ADDENDUM NUMBER 02

DATE: May 12, 2026

PROJECT: **CHEAHA STATE PARK FIRE STATION**

PROJECT NUMBER: **ASPD PROJECT #: 2026-005-16FS**

PROJECT NO: R08325001
 DATE: 04/17/2026
 SHEET NO:
 SCALE: AS SHOWN
 DRAWING TITLE: ENLARGED STAIR FLOOR PLAN AND ELEVATION
A06.01

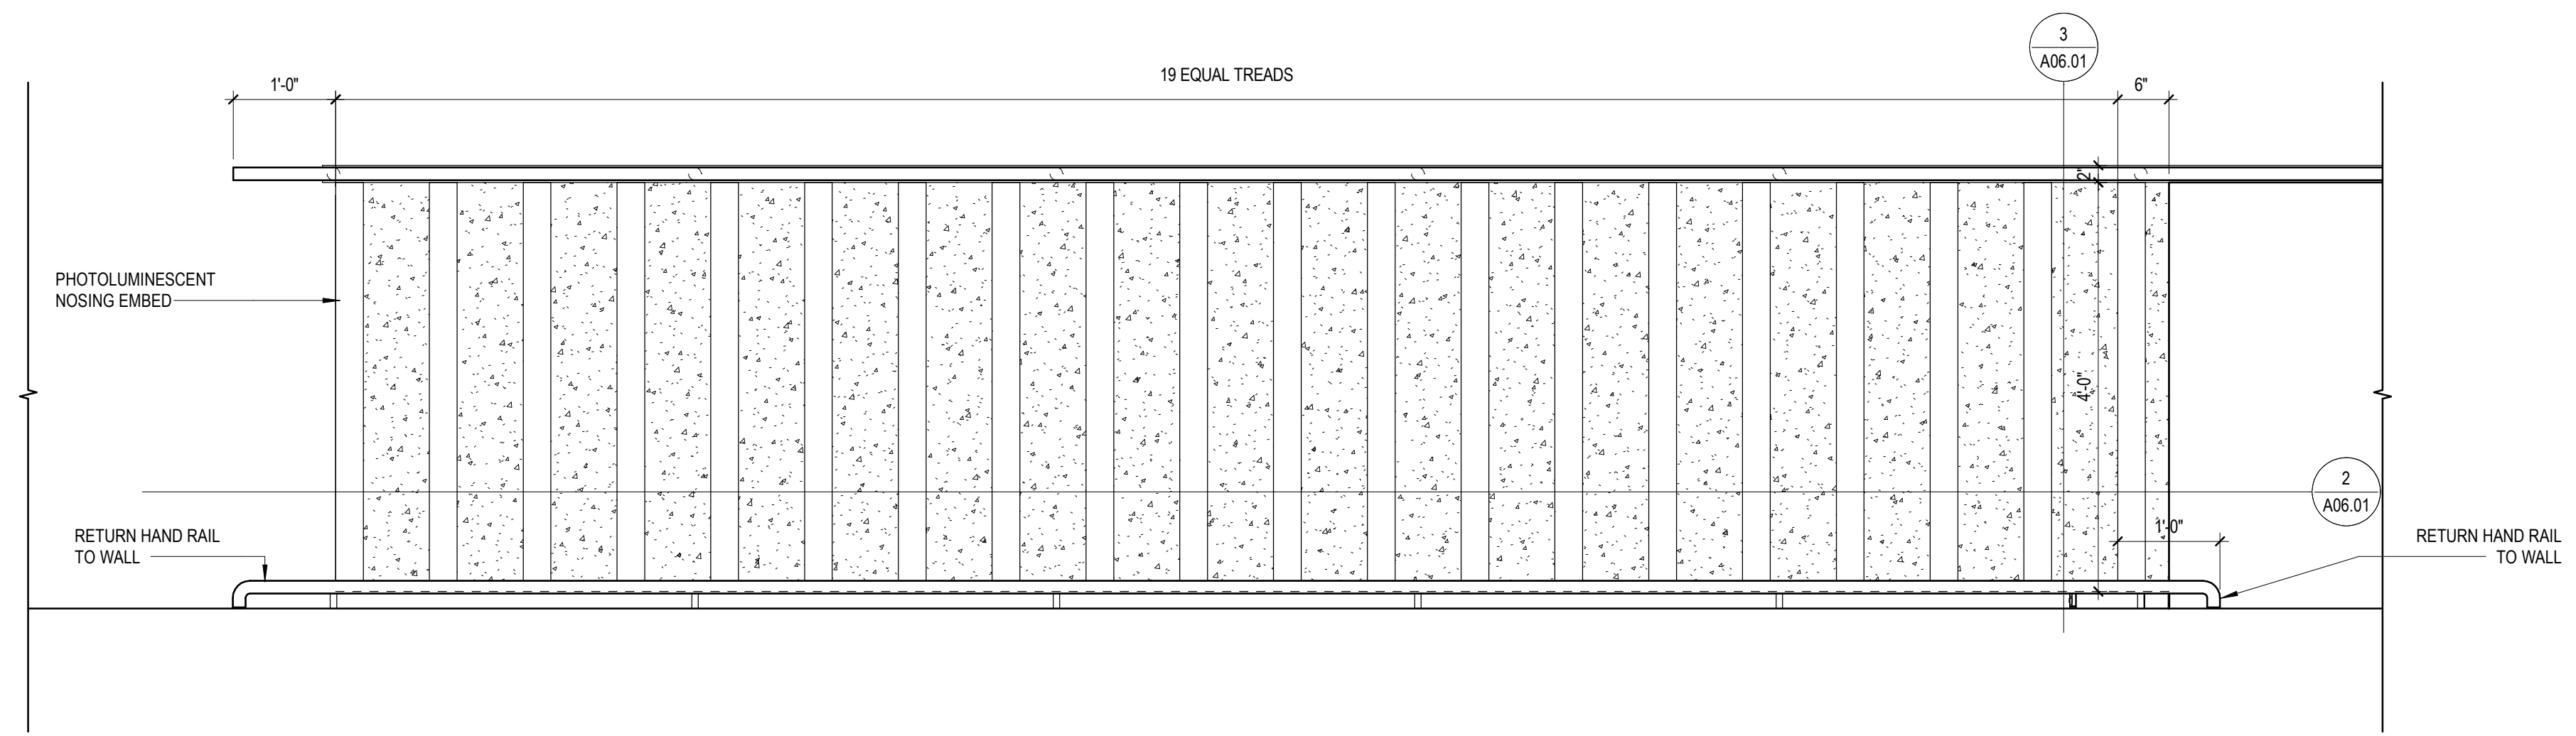
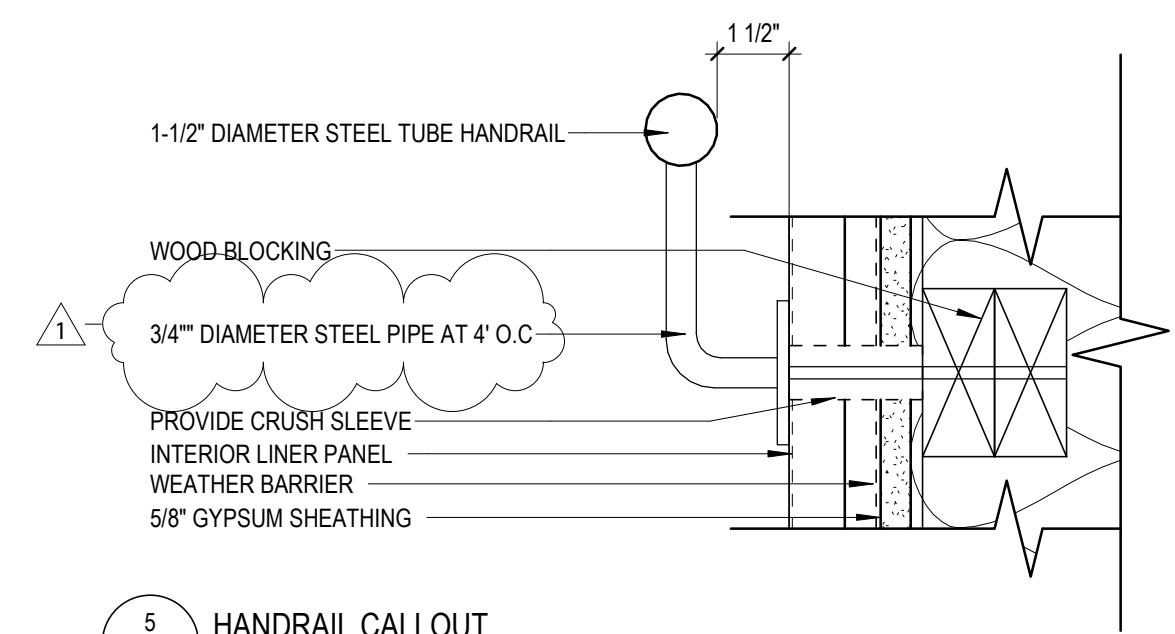
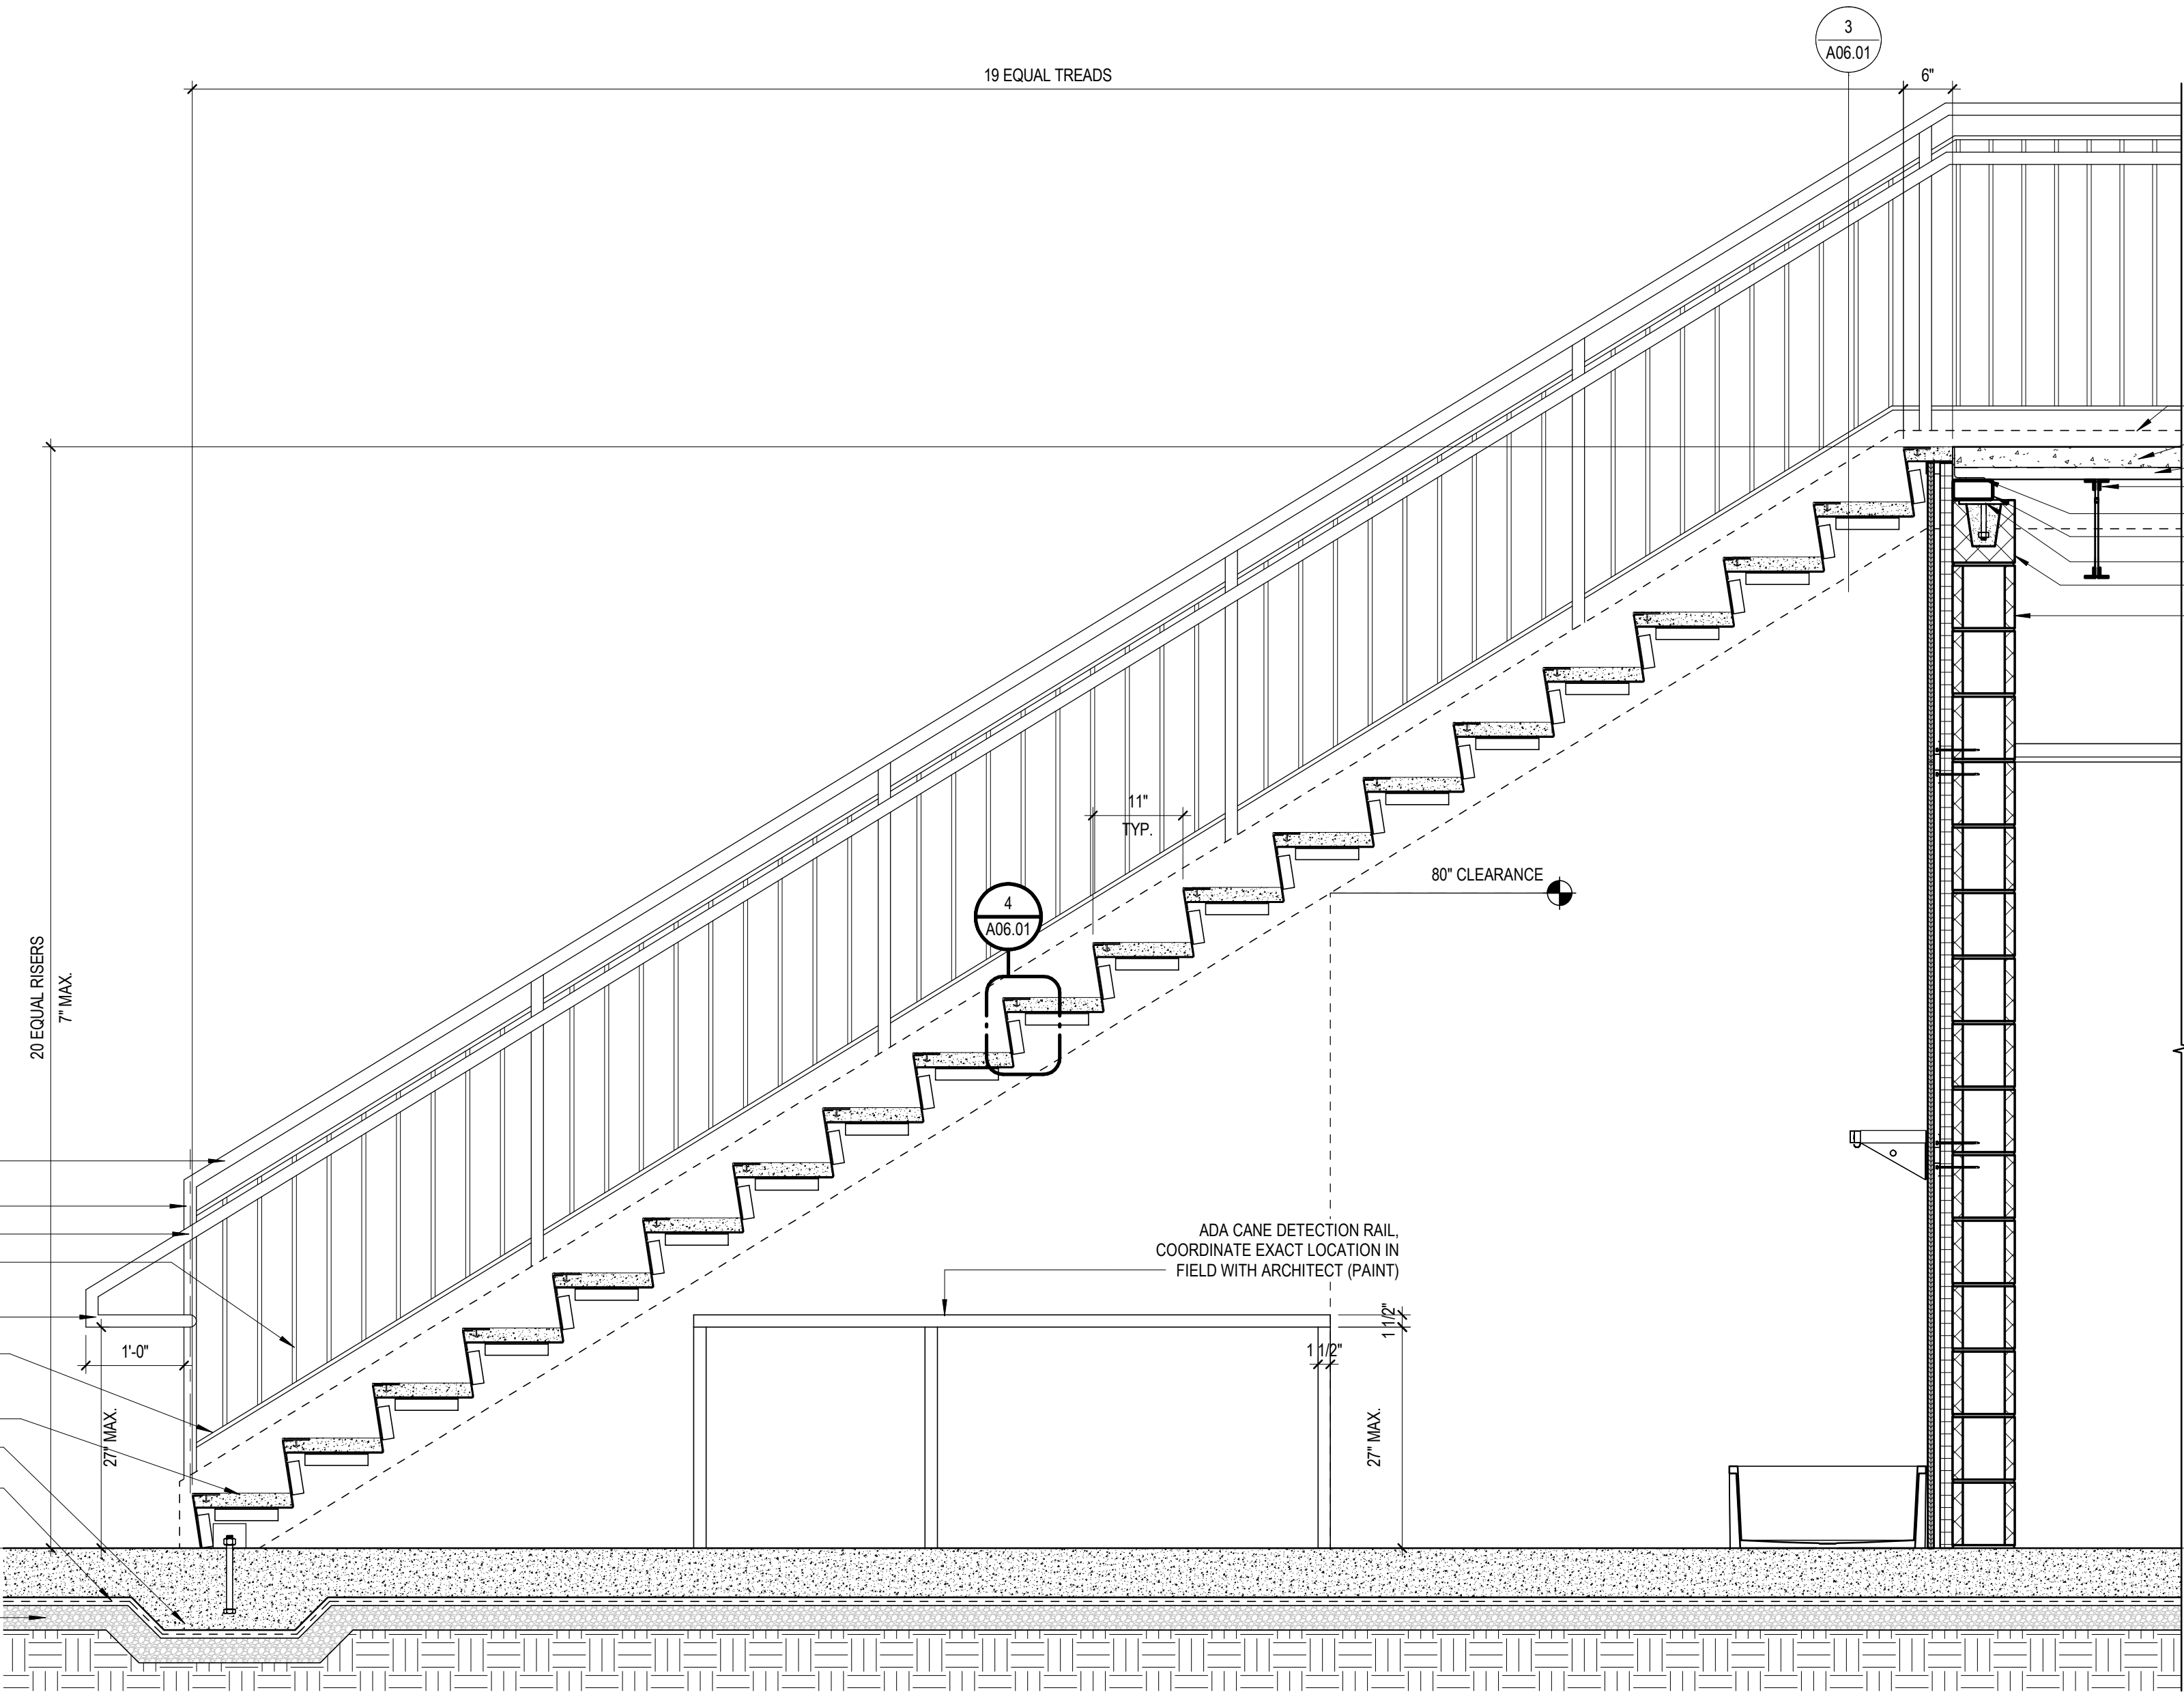
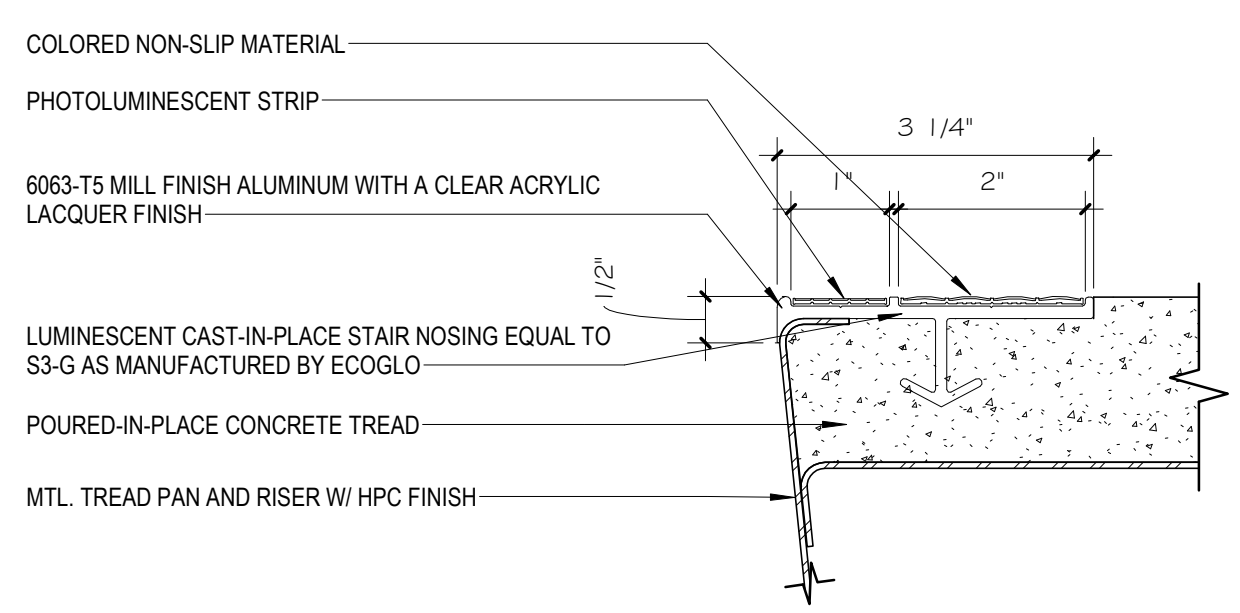
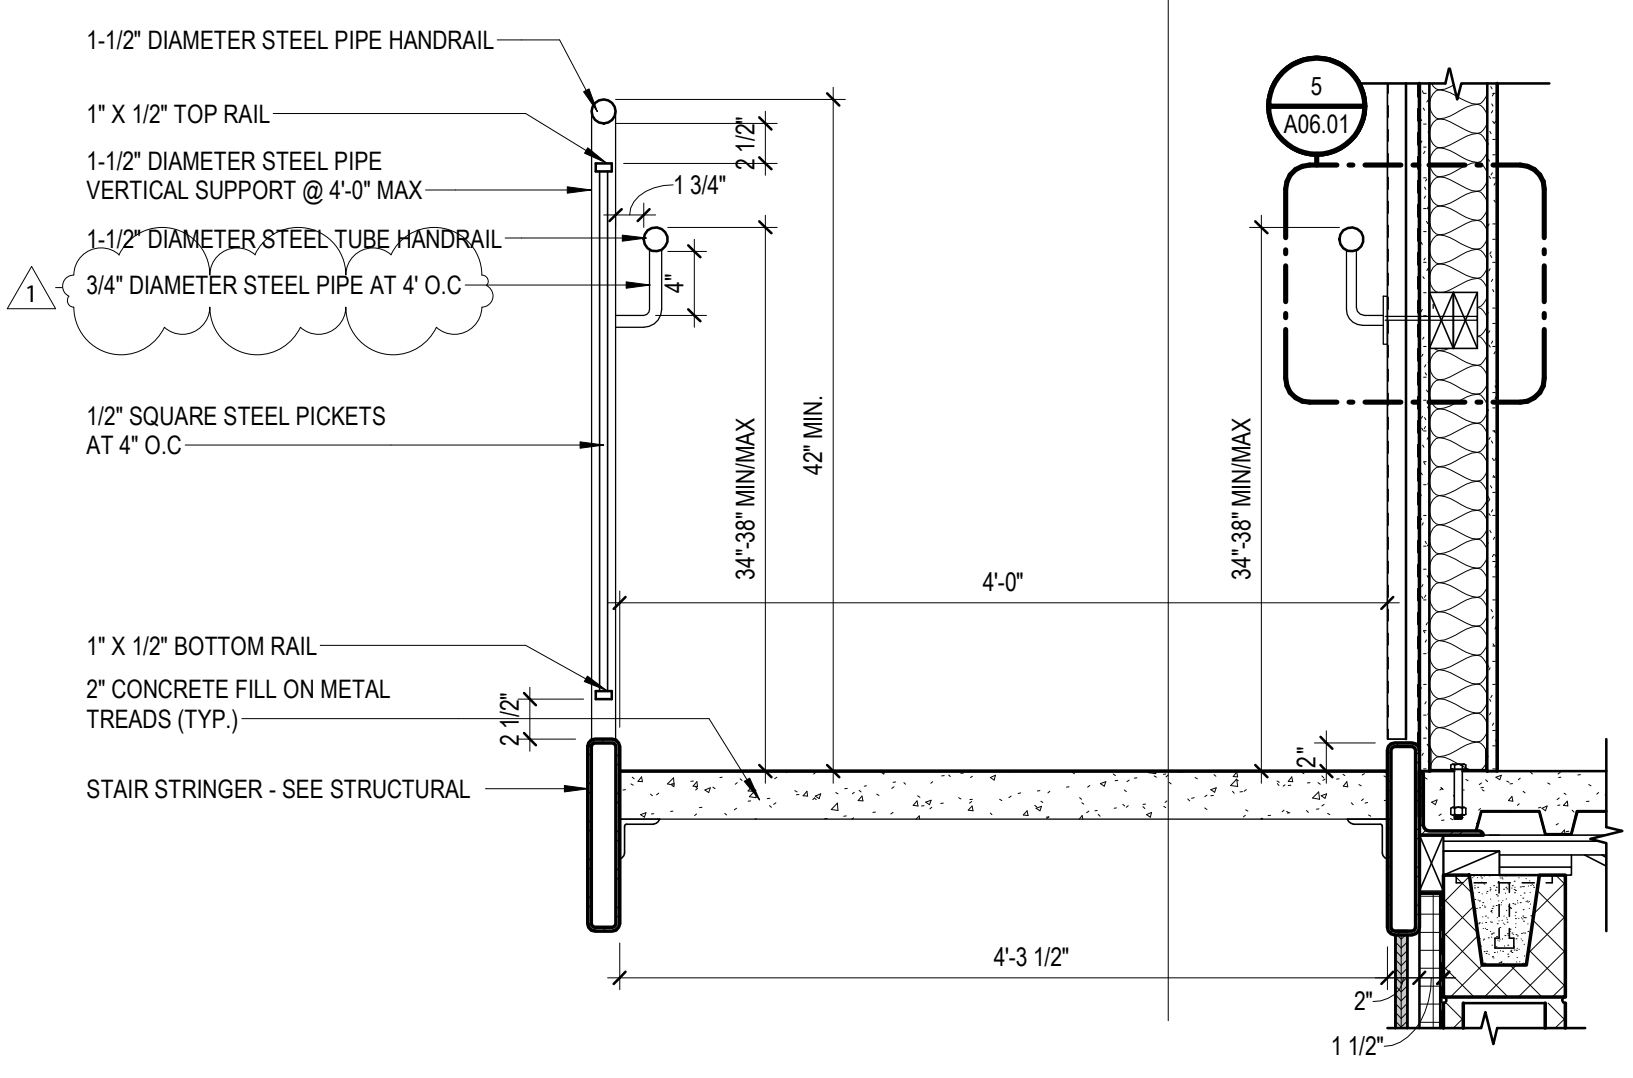
- a. Replace with the attached revised drawing.
 - b. Revision cloud reflects detail numbering change and the addition of FRT wall cap detail.
8. **Sheet A06-01 – ENLARGED STAIR FLOOR PLAN AND ELEVATION**

- a. Replace with the attached revised drawing.
 - b. Revision cloud reflects annotation correction.
9. **Sheet A08-00 – REFLECTED CEILING PLANS**
 - a. Replace with the attached revised drawing.

4. Detail 3 on Sheet A06.01 shows the 3/4" diameter steel pipe (stand-offs) at 4" OC. The same note is shown on Detail 5 for the wall rail. These are typically at 4' OC. Is this detail correct? **Refer to revised Drawing Sheet A6.01. 3/4" diameter pipe are to be at 4'-0" O.C.**
